Subject: **Praise Church – 901 North Broadway – Special Use Permit and Site Plan Approvals**

As requested, we have reviewed the Town Board special use permit and Planning Board site plan application for the renovation and adaptive reuse of 6,991 square feet of the existing 31,350 square foot office building as a church. The property is located at 901 North Broadway and located within the CB (Central Business) Zoning District.

Aerial View of Site

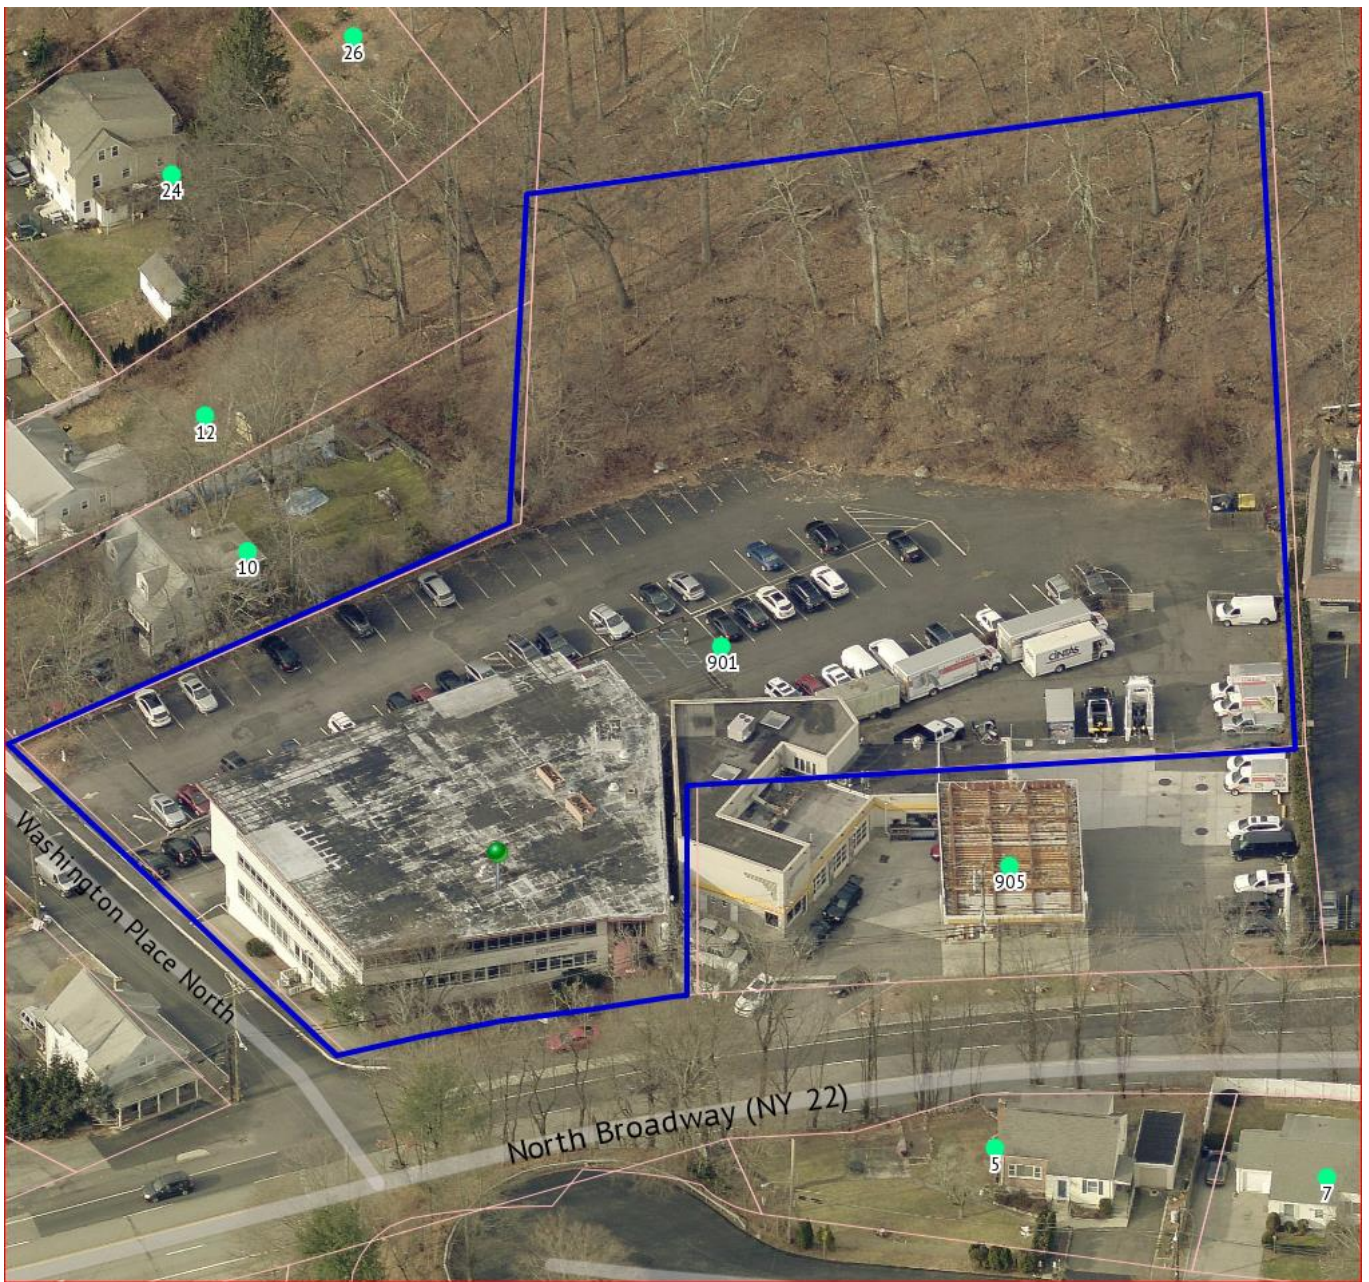
It appears that the required screening is not provided along the westerly property line adjacent to the R-2F Zoning District.
